**CERTIFICATE OF APPROPRIATENESS**

**Property:** 1548 Cortlandt Street, Tract 24A, Block 138, Houston Heights Subdivision. The property includes a historic 988 square foot, one-story wood frame single-family residence and a detached garage situated on a 5,000 square foot (50' x 100") corner lot.

**Proposal:** Alteration/Relocation/Addition – The applicant was denied a Certificate to relocate the contributing one-story residence on site, raise the foundation height 5", remove the existing side gable roof and rebuild the roof with a higher pitch and replace the original boxed eaves with classical eave returns, and to construct a two-story addition to the one-story residence at the November 2014 HAHC meeting. The applicant has resubmitted the application; the proposed scope of work is as follows:

**Recommendation:** Denial - does not satisfy criteria: 1, 4, 8, 9, and 10

**FIRST FLOOR PLAN**

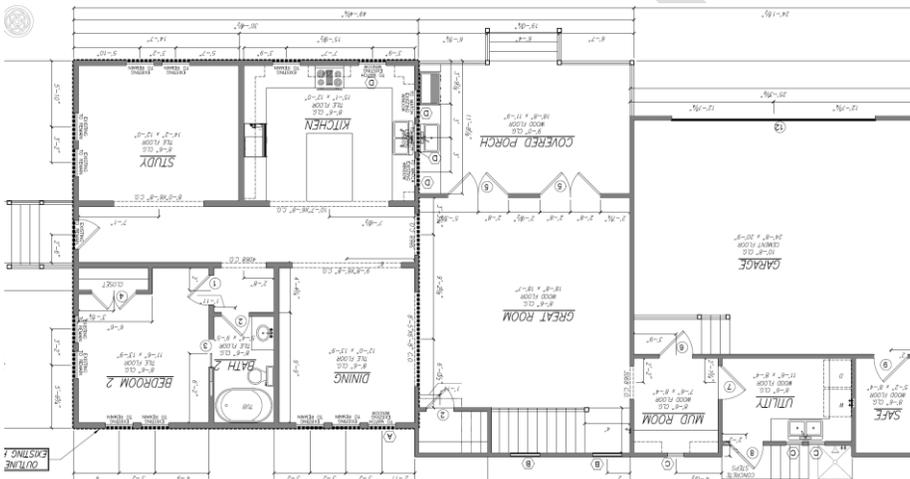
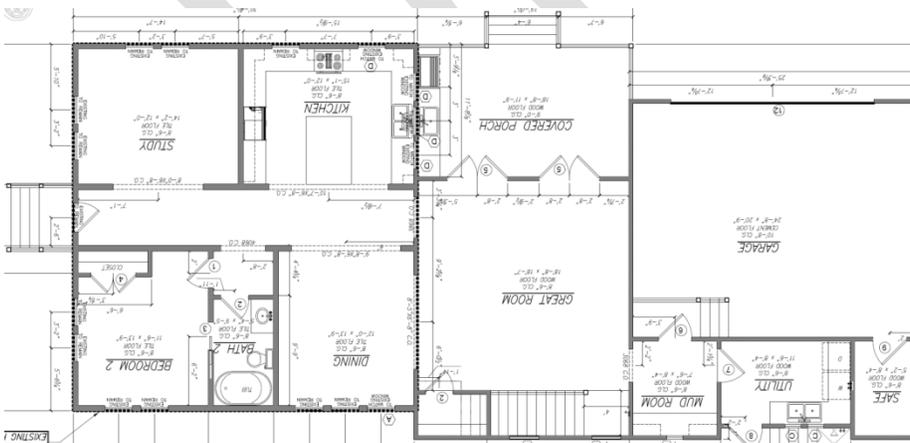
Sanborn maps indicate that this rear bay is original to the house.

**DEMO PLAN**

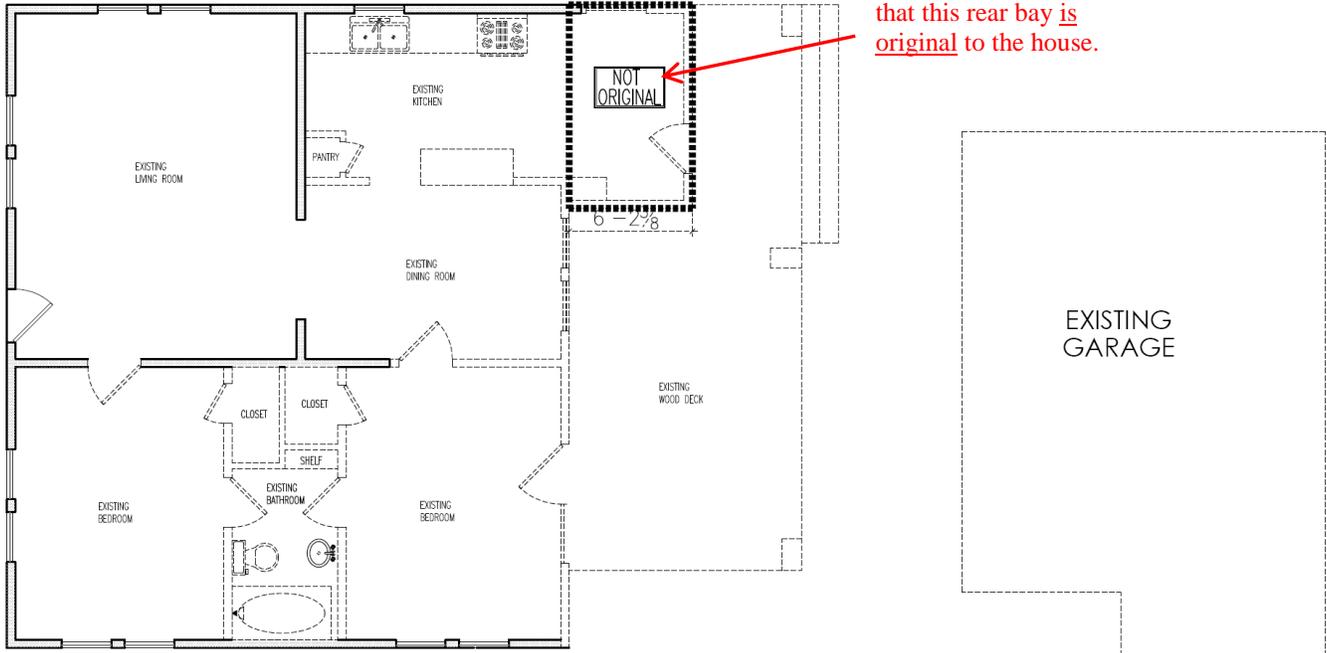
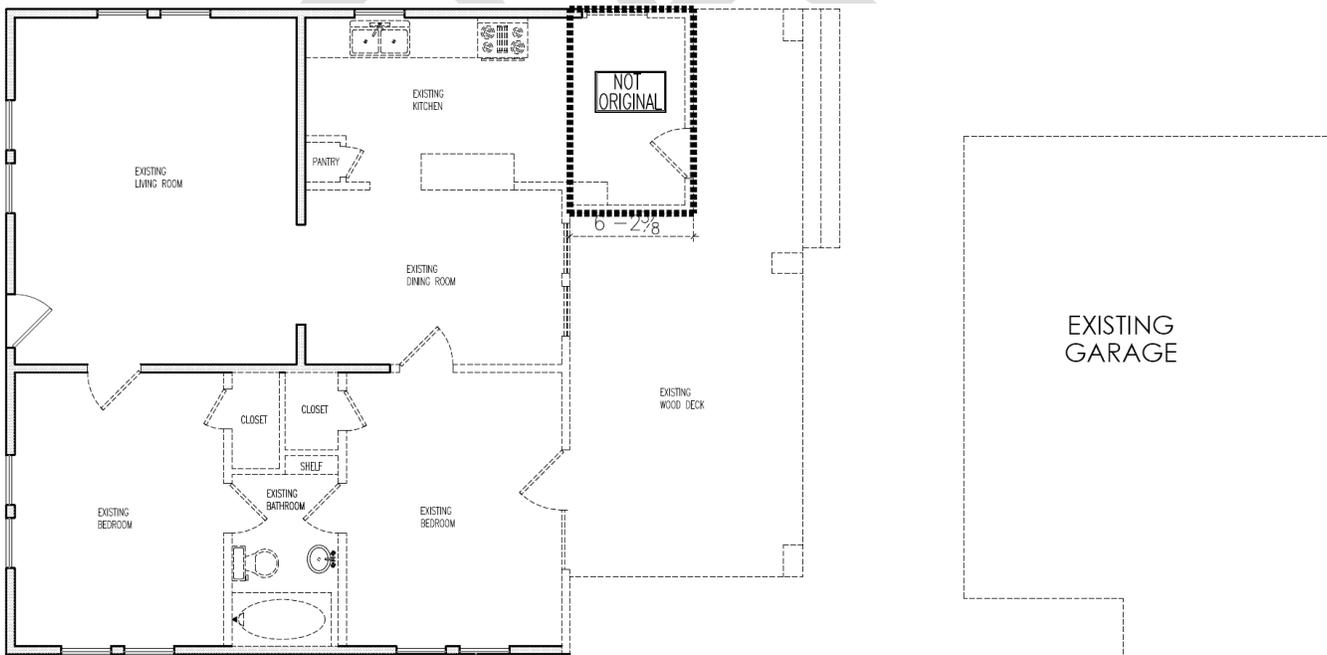
Sanborn maps indicate that this rear bay is original to the house.
